Access Compliance Report

Public Rights-of-Way (Curb Ramps)

Intersection ID: 28975	Main Street: BANNINGTON_RD	Cross Street: NORTHBURY_LN	Location: SW
ADA ID: 0D9047E1960C	Ramp Type: PerpDiag	Initial Pass/Fail: Fail	Overall Compliance: No Severity Score: 33.75

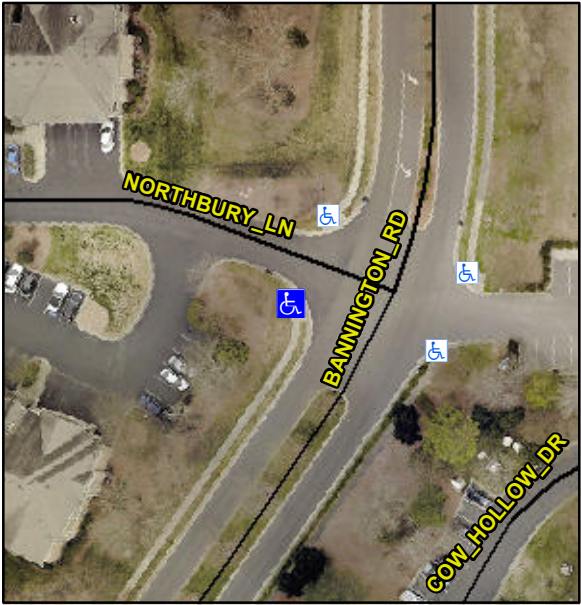
Codes/Mitigation Info/Possible Solution			Field Measurements/Component Compliance		
	Possible Solutions:		Compliance	Description	Data
	Remove & Replace Curb Ramp With Two New Directional Ramps or Equivalent.		N/A	Ramp Length (in)	95.0
			No	Ramp Width (in)	38.0
			N/A	Flare Type LT	N/A
			N/A	Flare Slope LT (%)	N/A
			N/A	Flare Traversable LT?	N/A
			N/A	Landing Length (in)	N/A
			N/A	Landing Width (in)	N/A
			N/A	Landing Slope (%)	N/A
			N/A	Landing X Slope (%)	N/A
<p>Surveyor Notes:</p> <p>N/A</p> <p>PROW/ADA:</p> <p>Not Found, R304.5.1, R304.5.3</p>			N/A	Flare Type RT	N/A
			N/A	Flare Slope RT (%)	N/A
			N/A	Flare Traversable RT?	N/A
			N/A	DWS Provided?	N/A
			N/A	DWS Contrast?	N/A
			N/A	DWS Length (in)	N/A
			N/A	DWS Full Width?	N/A
			N/A	DWS Offset (in)	N/A
			N/A	Shared Landing?	N/A
			N/A	Gutter Ponding?	N/A
			N/A	Gutter Lip Ht (in)	N/A
			N/A	Painted X Walk1?	No
				X Walk 1 Direction	To E
			N/A	X Walk 1 Width (in)	N/A

X Walk 1 Slope (%)	2.6
				X Walk 1 X Slope (%)	5.1
			N/A	Ramp inside XWalk1?	N/A
				Road Slope (%)	6.2
				Road X Slope (%)	2.2
			N/A	Any Obstructions?	N/A
				Obstruction Type	
Total Cost:			\$	3200.00
